**CITY OF BATON ROUGE  
PARISH OF EAST BATON ROUGE  
DEPARTMENT OF ENVIRONMENTAL SERVICES**

**ADDENDUM NO. 2**

SUBJECT: **PS 299 REGIONAL PUMP STATION**

**CITY-PARISH PROJECT NO. 20-PS-IF-0109**

C-19R

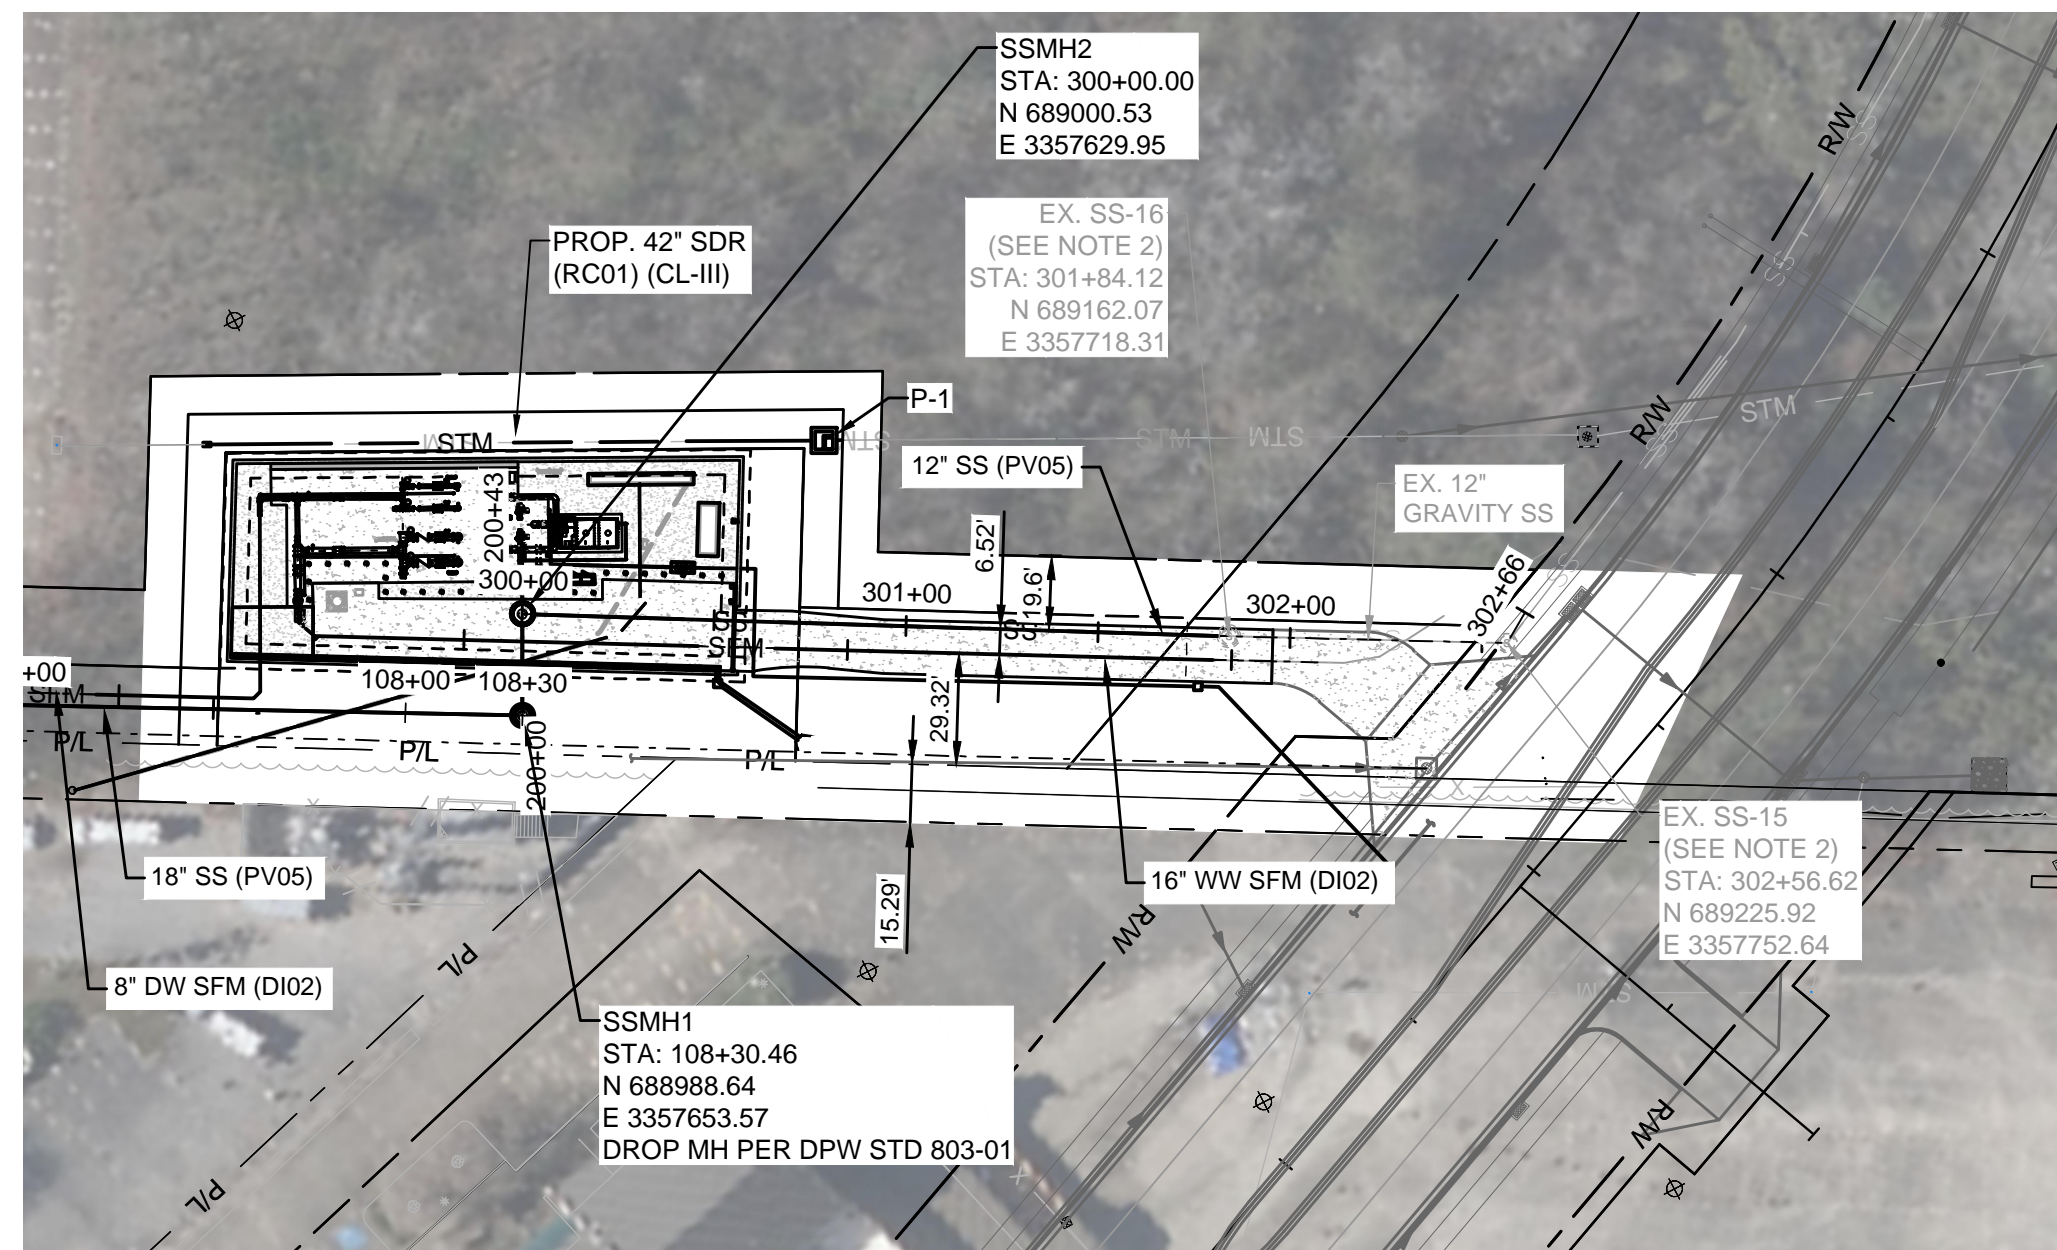
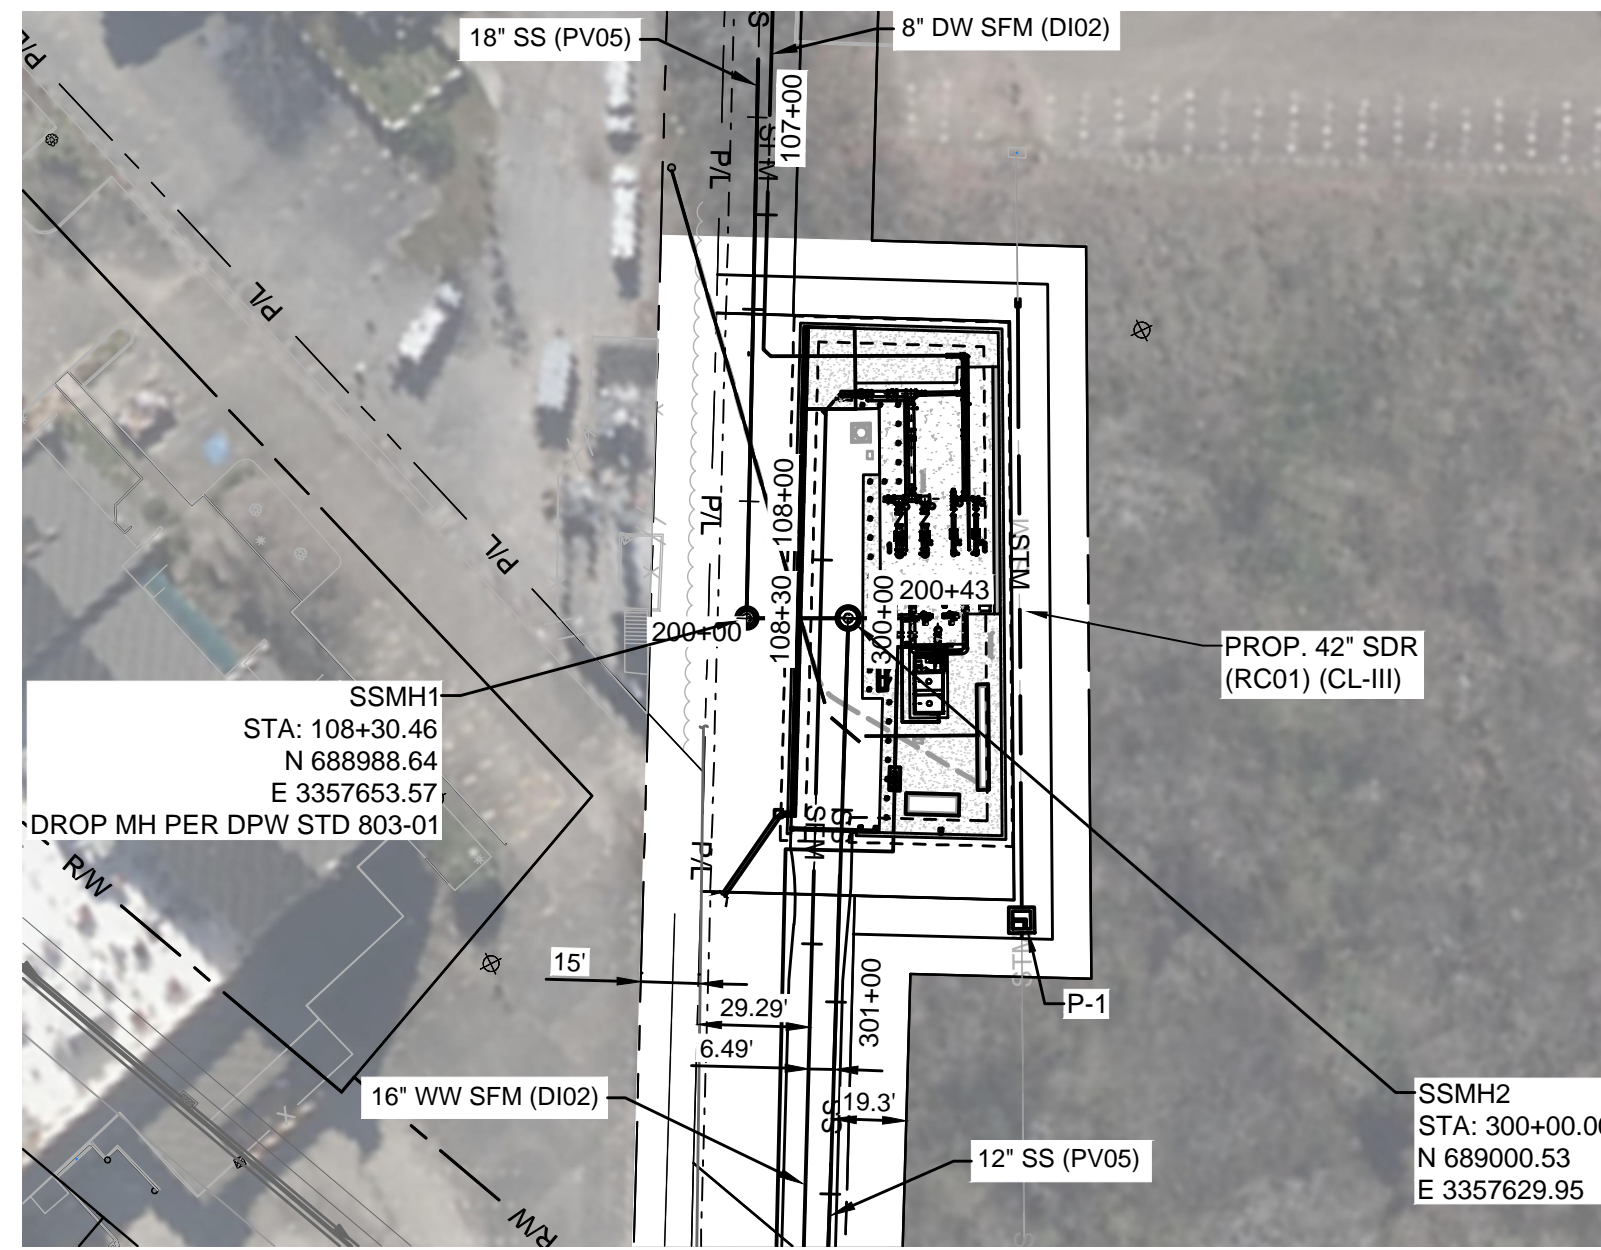
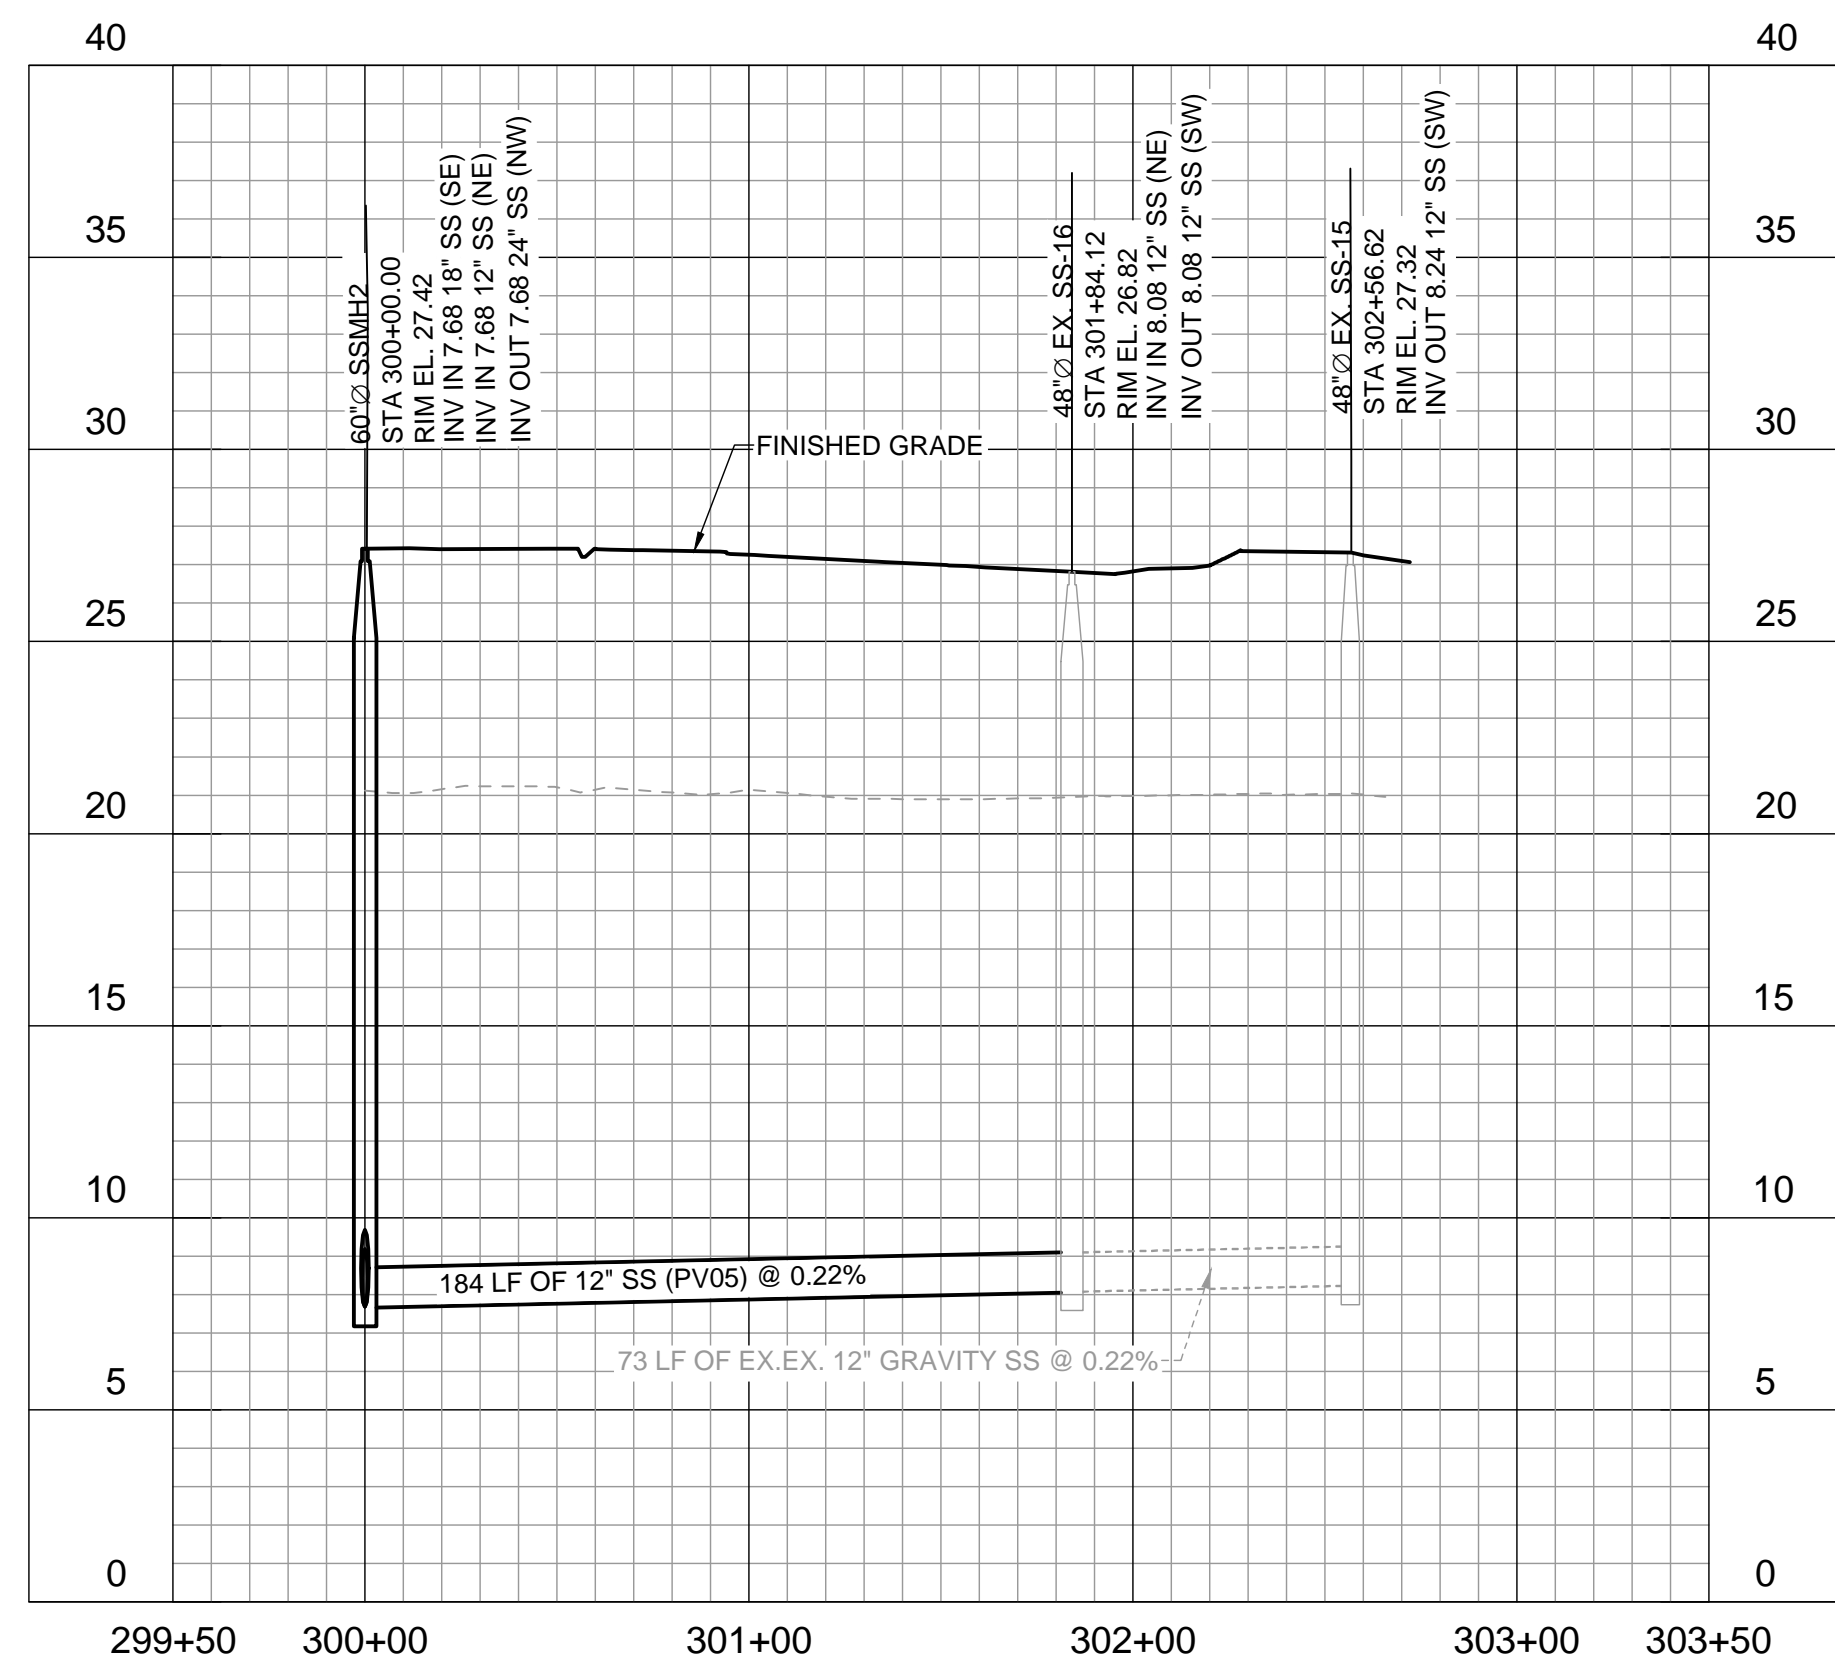
1. For paper sealed bidders, with reference to page UCBF 1 of 4 of Part 1, Uniform Construction Bid Forms, the Bidder shall indicate the receipt of this addendum in the space provided. For online Central Bidding bidders, an acknowledgement of this addendum will be prompted by the electronic bidding program prior to formally submitting the bid. **Failure to indicate the receipt of this addendum shall be cause for the bid to be rejected.**
2. DELETE Drawing C-18R and REPLACE with attached Drawing C-18R Civil Sewer Plan and Profile - I.
3. DELETE Drawing C-19R and REPLACE with attached Drawing C-19R Civil Sewer Plan and Profile - II.

1. The drawings in the addendum state all manholes shall include 1' thick walls, bottom slab, and top slabs. I am hearing from precast suppliers that this is only possible for 120" and larger diameter manholes so I do not think 1' thickness will be possible unless they are rectangular structures. General wall thickness for 60" manholes is 6" and 7" for 72" manholes.

The Contractor may deviate from the specified thicknesses, but are required to provide signed structural calculations, including buoyancy calculations as required by the note.
